143 Holm Avenue, Portland, Maine
sketch - not to scale

1st floor - APPROX

Reviewed for Code Compliance
Inspections Division
Approved with Conditions

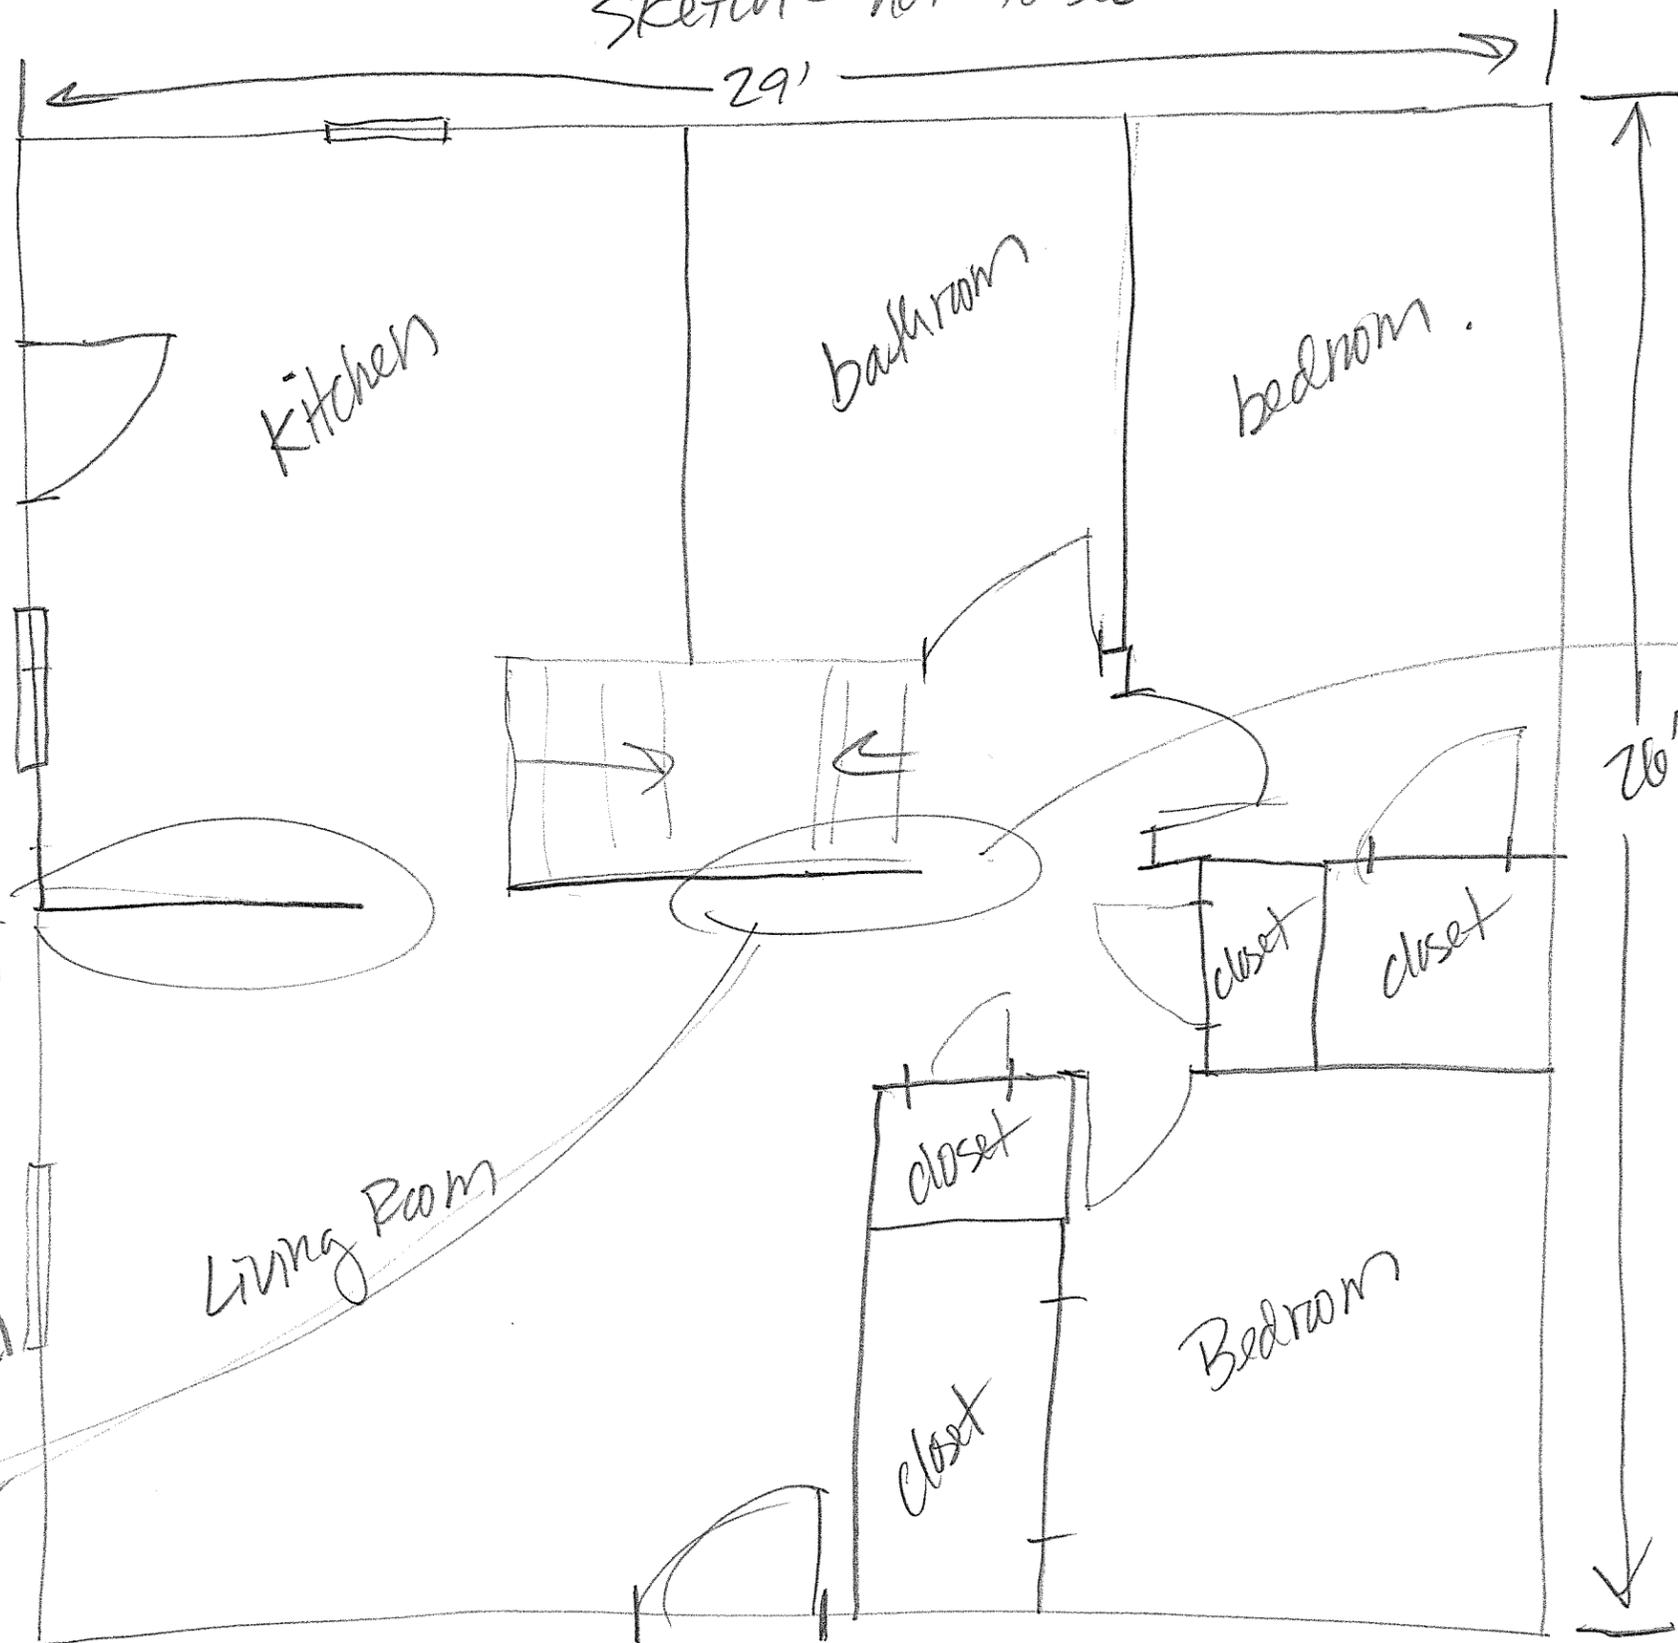
Remove 1/2 wall
and install beam
for support.

cutback staircase
wall and install
beam for
support

cutback section
of wall to open up
staircase.

Beam installed
for support.

Remove ramp at front door
and rebuild steps to
side door.
